Technical Service Bulletin

No.LTB00123v4
29 October 2009

Subject/Concern : Front Suspension Knock Diagnosis

Models :		
Discovery 3 / LR3		VIN- range : 000360-513325
Discovery 4/LR4 (LA)		VIN- range : 513326 Onwards
Range Rover Sport (LS)	Vehicles Without Dynamic Response Only	Vehicles Without Dynamic Response Only VIN- range : 900290 Onwards

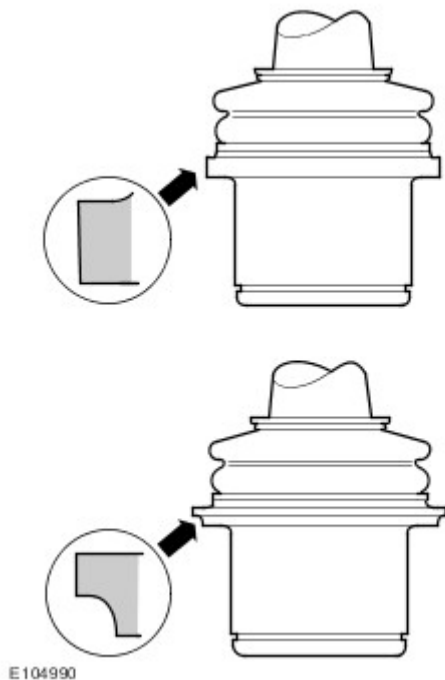
Check that the latest lower suspension arm ball joint design is fitted to the vehicle. The new type of joint has a radius on the edge of the mating face. See bottom image on Fig. E104990.

- 1 . If the earlier type of ball joint is fitted replace with the new type. If the new type is fitted continue to step 2.

- 1 . **NOTE :** If replaced and the new type ball joint is found to be loose within its location in the lower suspension arm, then replacement of the lower suspension arm is required.

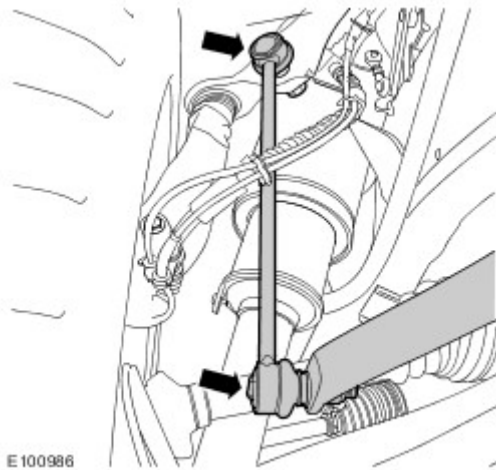
Using a hydraulic telescopic jack (for example, a transmission stand), raise the lower arm until the distance from the centre of the wheel hub to the wheelarch is 455mm.

- 8 . Locate a suitable bar on the top of the hydraulic stand and bring to bear against the bottom of the ball joint ballpin thread.
 - 1 . It is now possible to lift the bar and any axial play present in the ball joint will be immediately apparent.
 - 2 . It may be necessary to lift/lower the ballpin several times to displace grease present inside the ball joint.

- 9 . If free play is found in the lower ball joint, replace the lower ball joint and carry on from step 10. If no play in the lower ball joint, carry on from step 10.
- 10 . To install the suspension spring / damper lower mounting bolt, reverse removal procedure

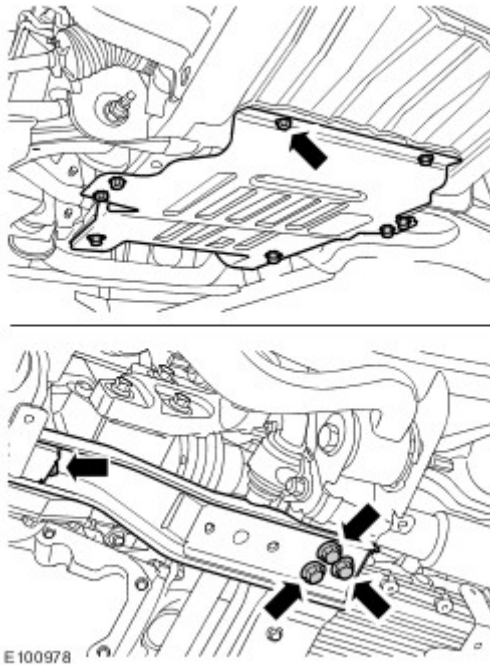
- 30 . Remove engine undershield (see Global Technical Reference GTR Workshop Manual, section 501-02).
- 31 . **NOTE** : Check the Torque of the four arrowed fixings in the lower part of E100978 only.

Check torque of front differential cross member fixings.
